CERTIFICATE OF APPROPRIATENESS

Property: 802 Arlington Street, Tracts 13A & 14A, Block 250, Houston Heights Subdivision. The property includes a historic 2,210 square foot 1½-story wood frame single family residence and attached garage situated on an 8,200 square foot (100' x 82') corner lot.

Proposal: Alteration – Revision. This property previously received a COA in December 2014 for a revised addition. In this application, the applicant requests to:

SOUTH SIDE ELEVATION – FACING E. 8TH STREET

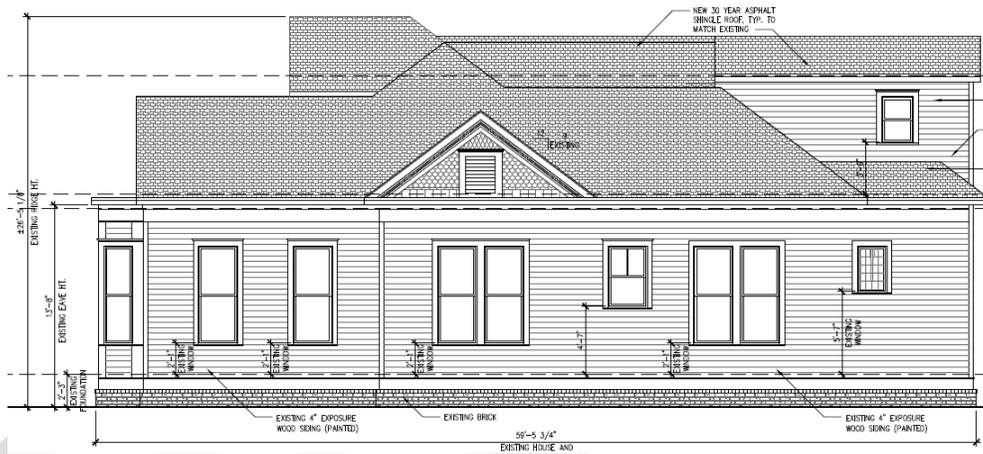
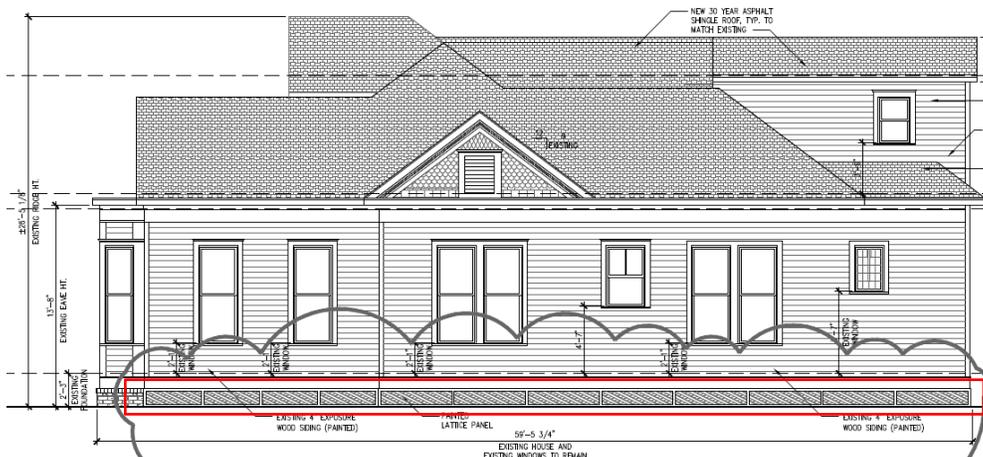
- Replace existing non-original brick skirting on the north and south elevations with wood lattice (the porch and front elevation will retain the brick skirting)
- Replace previously approved rear screen panels with wood siding

The existing brick skirting on the north and south elevations will be replaced with wood lattice panels. However, the brick skirting on the porch and front elevation will be retained. The previously approved rear screen panels will be replaced with wood siding. See drawings for more detail.

EAST (REAR) ELEVATION
EXISTING

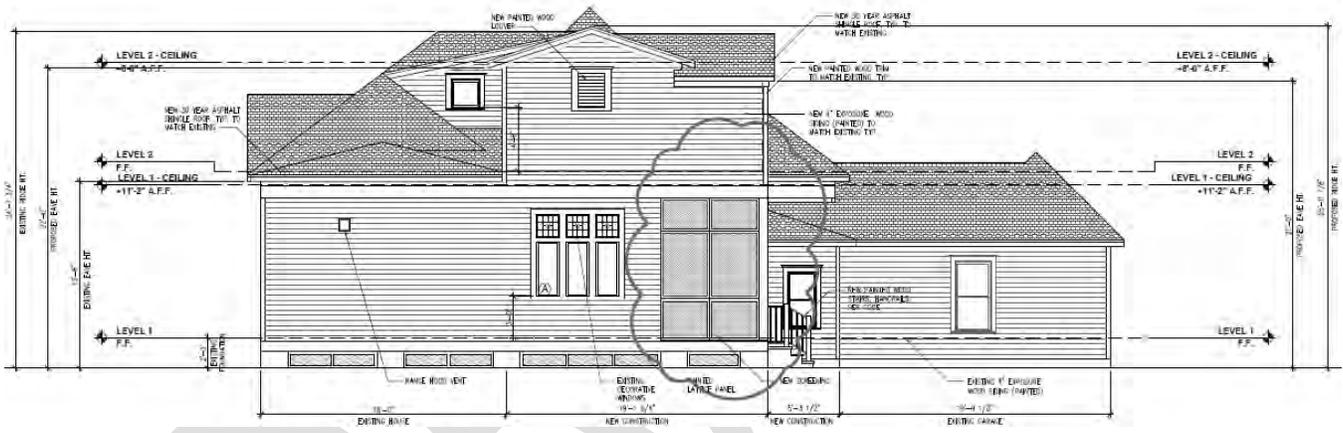
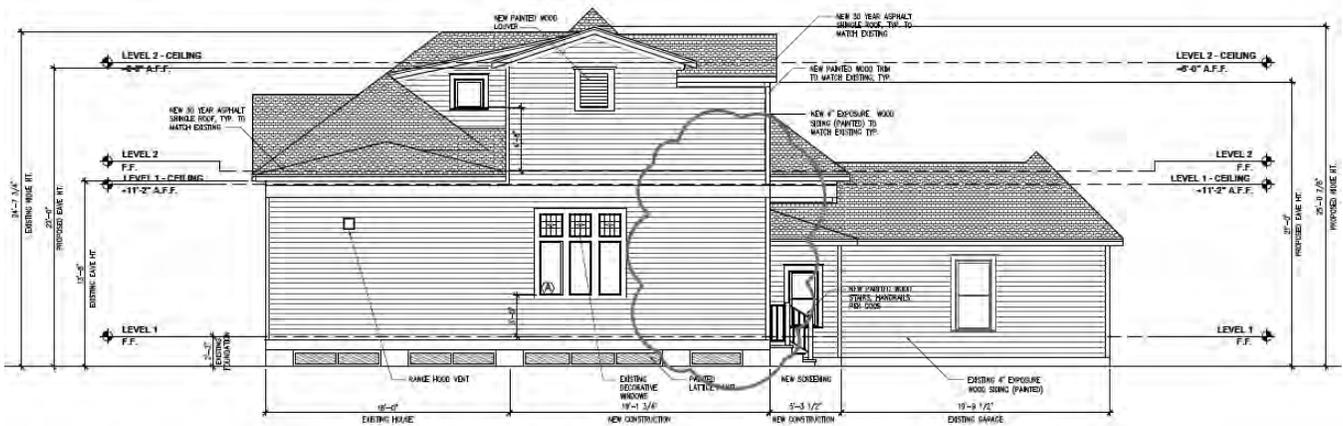
In the revised proposal, the screen panels on the rear elevation will be eliminated and will now be a wall clad with siding. See drawings for more detail.
